**Planning Board – Monday, September 23, 2019, 6:30PM**  
**City Hall Council Chambers – 3 Washington Street, 2<sup>nd</sup> floor**

**AGENDA**

2. **SPR-876, Modification #1 – Ametek (formerly Precitech) – 44 Black Brook Rd – Site Plan –** Applicant Brickstone Land Use Consultants LLC, on behalf of owner NH Black Brook LLC, proposes a 7,870 sf building addition and the installation of new parking areas to the north and east of the existing building for the property located at 44 Black Brook Rd (TMP #221-021-000). A waiver is requested from Planning Board Standard #6, Landscaping. The applicant requests a Surface Water Protection Conditional Use Permit to install paving and grading in a 1,600 sf area within the wetland buffer. The site is 18.43 acres and is located in the Corporate Park District.

**Proposed Site Plan**  
Design Development  
Colonial Theater Group, Inc.

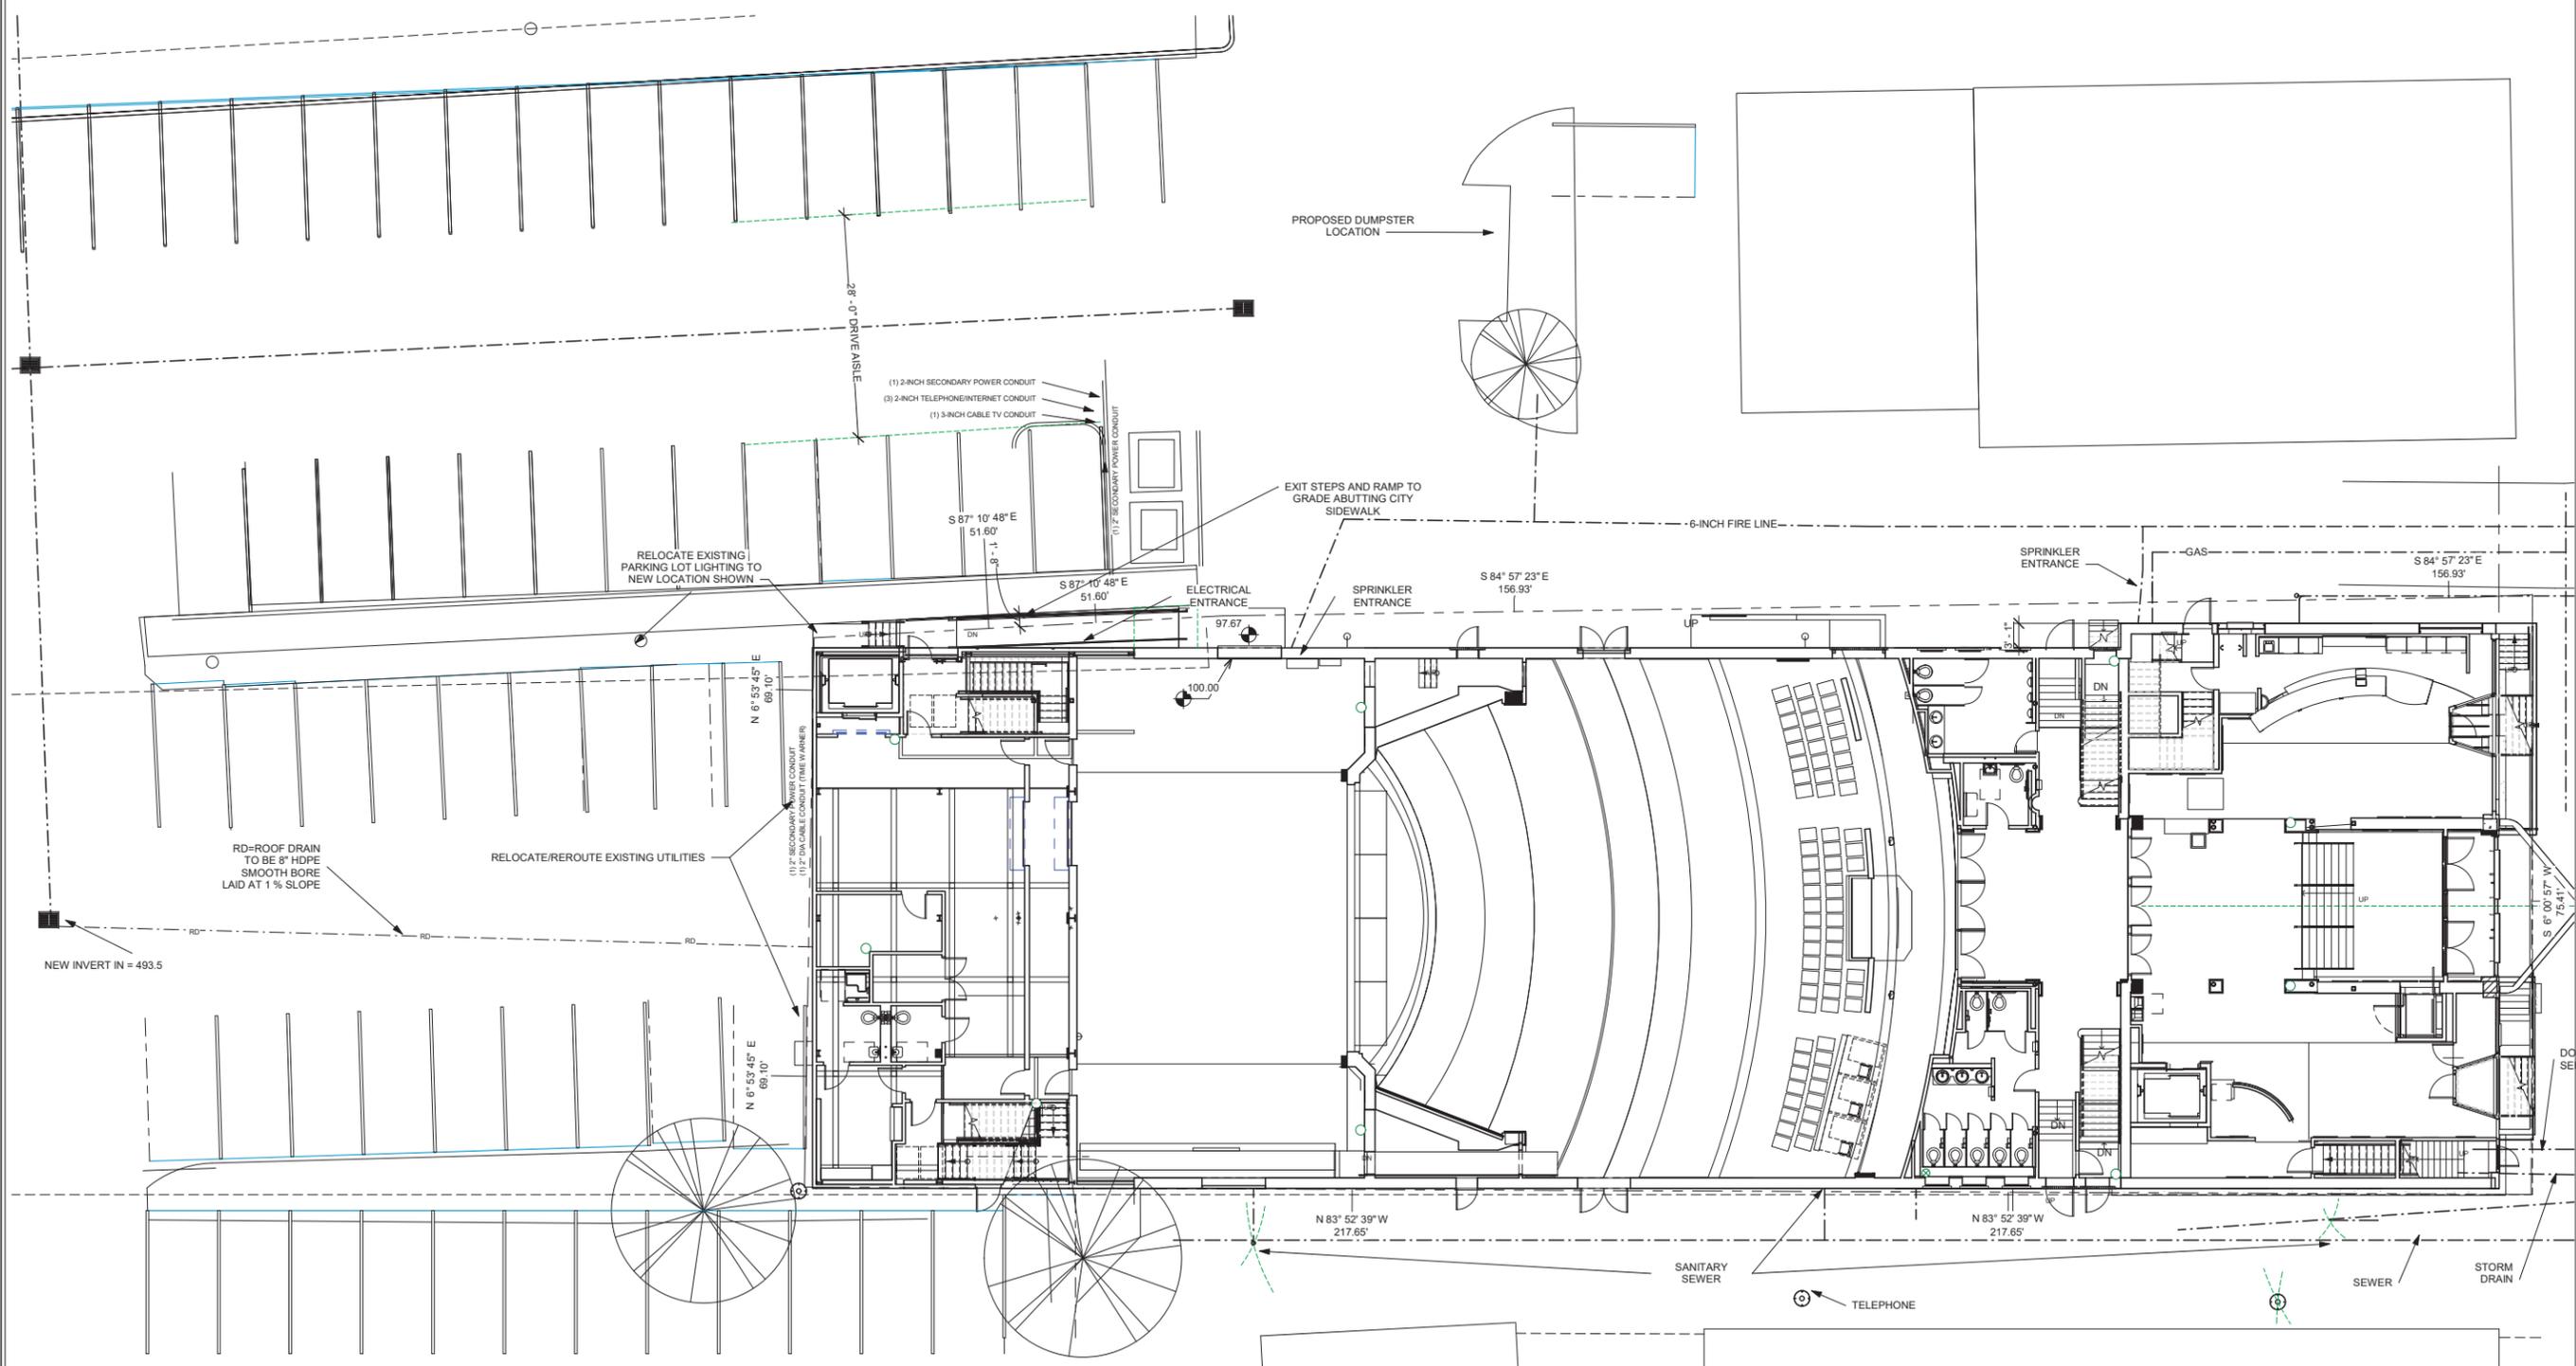
- Fire: No comments
- Code Enforcement: No comments
- Police: No comments
- Engineering:
  1. The plans appear to show a new concrete ramp extending into the adjacent City parcel. This will require a license from City Council.
  2. Applicant will need to obtain an encumbrance permit from the Public Works department prior to any work which will obstruct the public way or sidewalks.
  3. Modifications or relocations of City-owned conduit shall be completed as directed by the Public Works Director.
  4. Please provide drainage calculations for pre- and post- development conditions to demonstrate no net change in runoff. Specifically, calculations should account for roof drain and impervious spaces shown on Drawing.

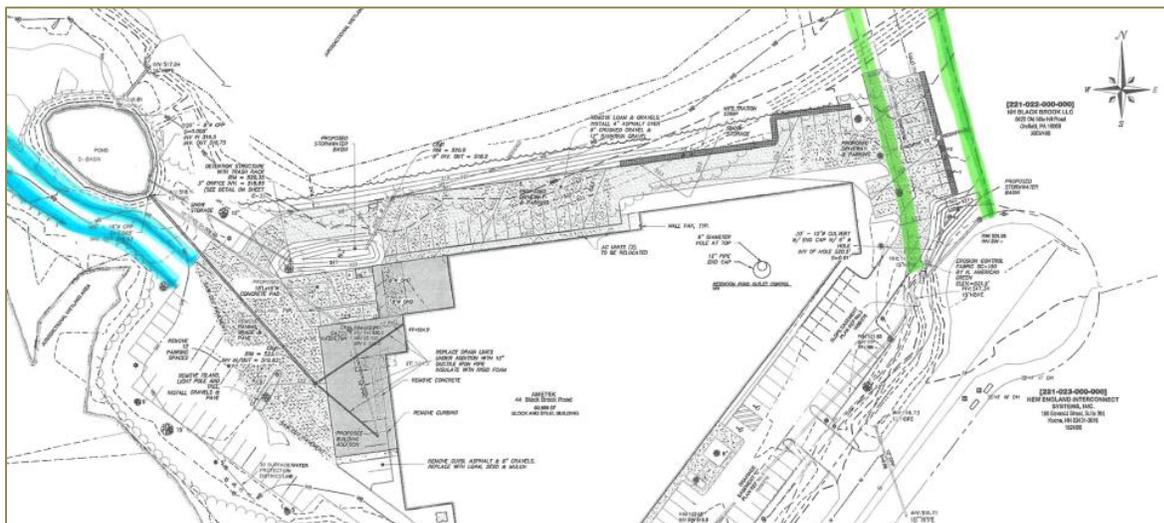
8. **Screening:** The applicant proposes to re-locate a truck loading dock and install a dumpster and dumpster pad in the paved area to the northwest of the existing building. This area is screened from view from Black Brook Road by the proposed new building addition, and is screened from view from Wyman Road by forested land. This standard appears to be met.

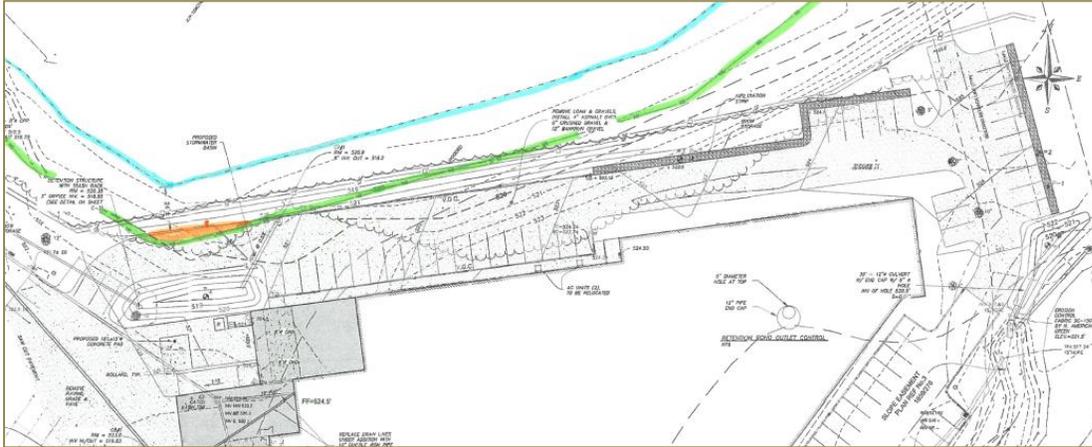
16 & 17. Wetlands and Surface Water: There are wetlands present on the property to the north and west of the existing building. The applicant proposes to install pavement and grade a 1,600 SF area within the 30-foot wetland buffer. The image below shows the wetland buffer highlighted in green, the edge of the wetland highlighted in blue, and the paved area within the wetland buffer highlighted in orange.

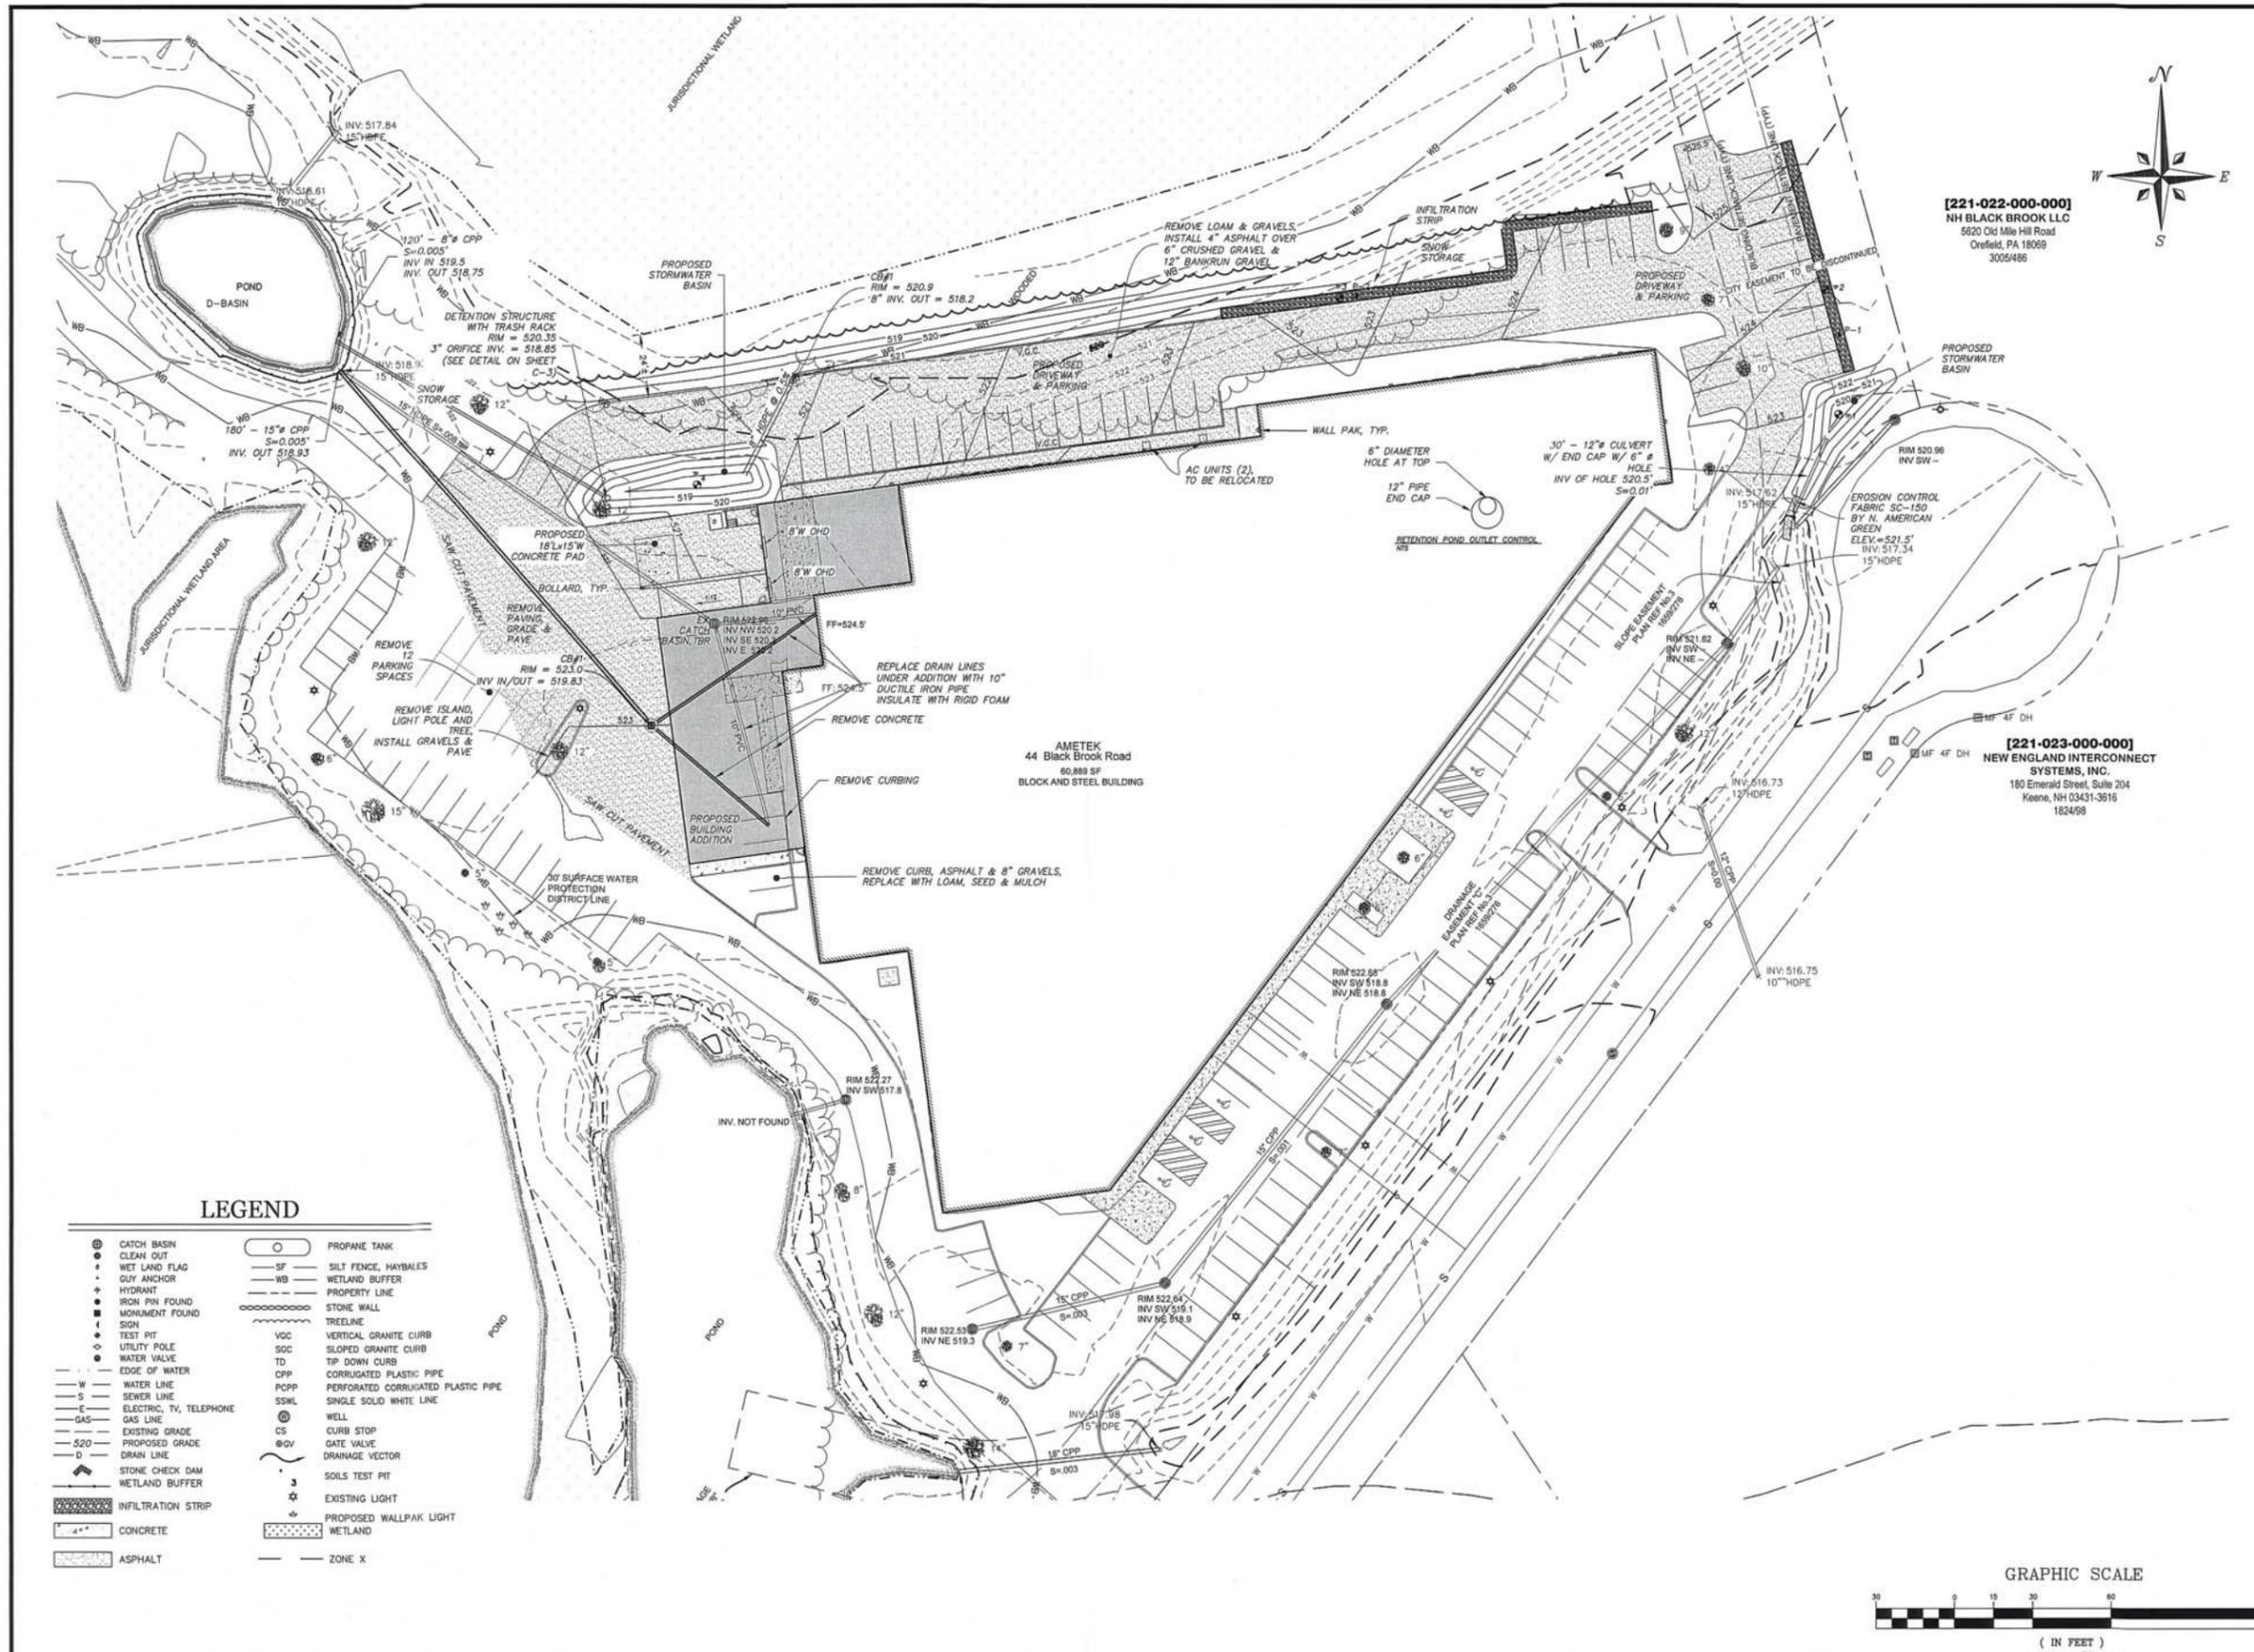
In response to staff comments relating to the site plan:

5. The legend on the plan has been revised to reflect all symbology used in the drawings.
6. Sheet C-1 has been clarified to differentiate between existing and proposed conditions.

7. A test pit and perc test were performed at the site by SVE Associates. The results have been added to the Notes sheet N-1 and the drainage report. Test pit locations are shown on the Grading and Drainage plan.
